X-TYPE

XT308-02

TECHNICAL BULLETIN

Clutch Pedal Sticking Down –
Install Additional Spring –
Repair

ILLUSTRATION 1

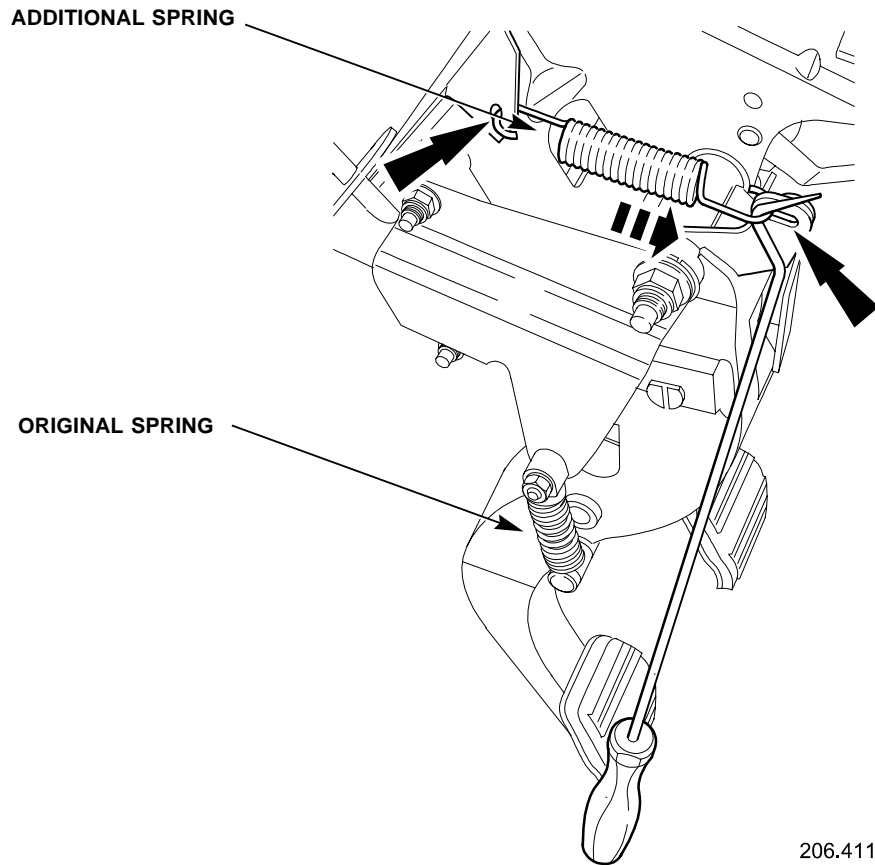
On some 2002 MY-ON X-TYPE vehicles with manual transmissions, customers may complain that the clutch pedal will stick in the down position intermittently, and will not return unless lifted manually.

A new spring has been released that can be installed in addition to the existing spring, in order to alleviate this concern.

3. Install one end of the new spring to the clutch pedal housing bracket. Install the other end of the new spring to the clutch pedal bracket (Illustration 1).

Note: A suitable tool ('Snap On' A1710 or similar) will be required to aid with the installation of the new spring to the clutch pedal. The tool should be long enough to be used by both hands to generate enough force to expand the spring.
